INDEPENDENT EXPERT ADVISORY PANEL FOR MINING

**ULAN COAL EXPANSION
PROJECT (08_0184)**

Modification 6

IEAPM Report No. 202410-1

Figure 3: Ulan Mod. 6 Amended Mine Plan

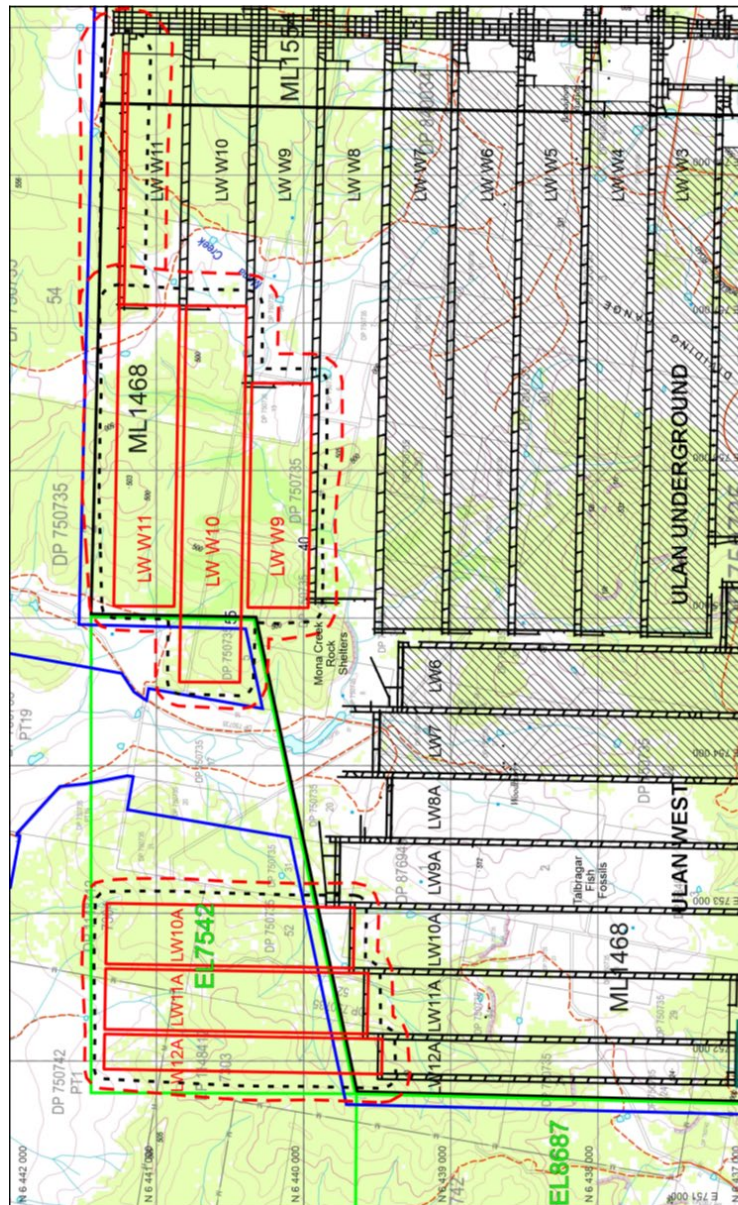
The Panel notes that the Amendment made by Ulan in late 2023 to the original 2022 Mod. 6 mine plan has involved shortening of the proposed Ulan Underground longwall panels for a number of reasons, which included avoiding undermining the Mona Creek 4th order stream. The amended panel boundaries are now set back beyond a 26.5° angle of draw from the stream banks. This is considered by the Panel to be a prudent measure to minimise any subsidence-related impacts on the stream and associated surface and near-surface groundwater issues.

It is significant to note that maximum subsidence may be as high as 2.1m and tensile strains of up to 25 mm/m, which will undoubtedly result in significant open surface cracking, especially over the shallower depths of mining. This is consistent with what the Panel observed over Ulan West LW7 during the site inspection.

The Panel is satisfied that the proposed mine plan for the Ulan Mod. 6 Amendment will result in subsidence effects and impacts within the range of predictions by SCT and that these will generally fall within the level of impacts already experienced above previous longwall panels at Ulan.

Figure 4: Current Northern Groundwater Monitoring Network
(partial reproduction from Figure 5.2 of Glencore 2024a)

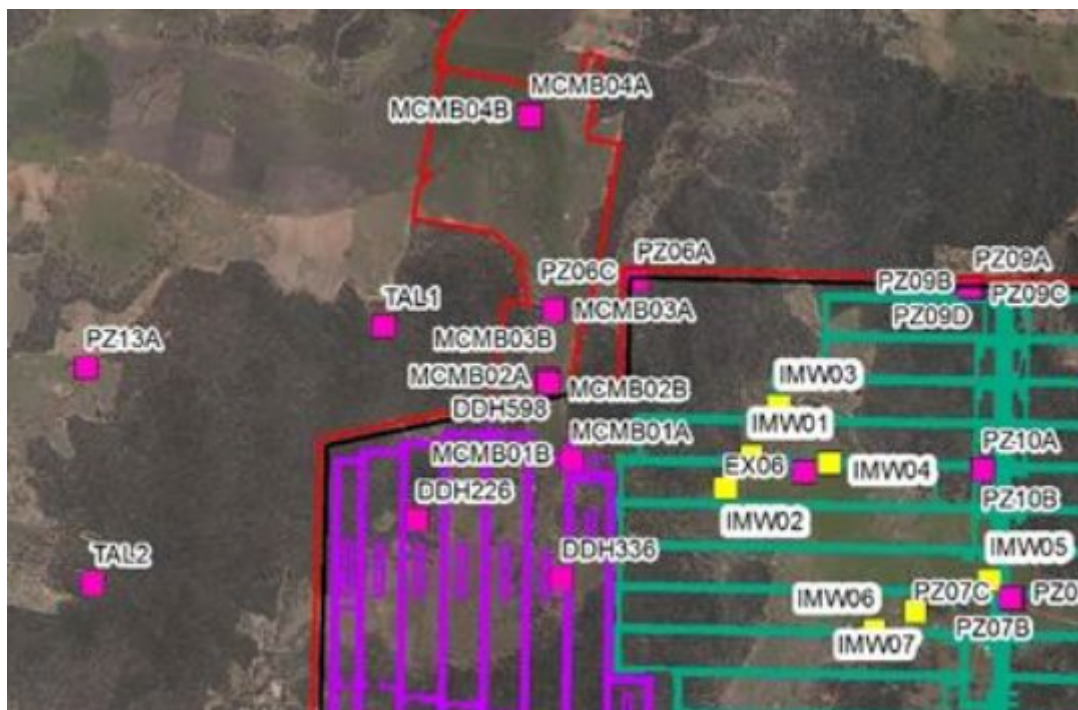
There is good spatial coverage but given the extent and magnitude of predicted drawdown to the north west towards the Talbragar River in the Permian and Triassic groundwater systems, and potential

baseflow reductions to the alluvium from these depressurised groundwater systems, it would be useful to establish deeper nested piezometers in the Permian overburden and Ulan Seam next to monitoring site MCMB04, and to construct new nested piezometers or a VWP monitoring bore (across the alluvium, Triassic sandstone, and Permian overburden and Ulan Coal Seam) close to the confluence of Mona Creek with the Talbragar River.

- The North Monitoring Network provides reasonable spatial coverage but additional shallow (alluvial) and deeper (Triassic and Permian) piezometers are required in the Mona Creek

catchment closer to the Talbragar River and additional piezometers are required in the Jurassic Pilliga Sandstone north of the amended project area.

4. The north monitoring network be expanded by adding deeper nested piezometers next to MCMB04, and constructing new nested piezometers or a VWP monitoring bore close to the confluence of Mona Creek with the Talbragar River
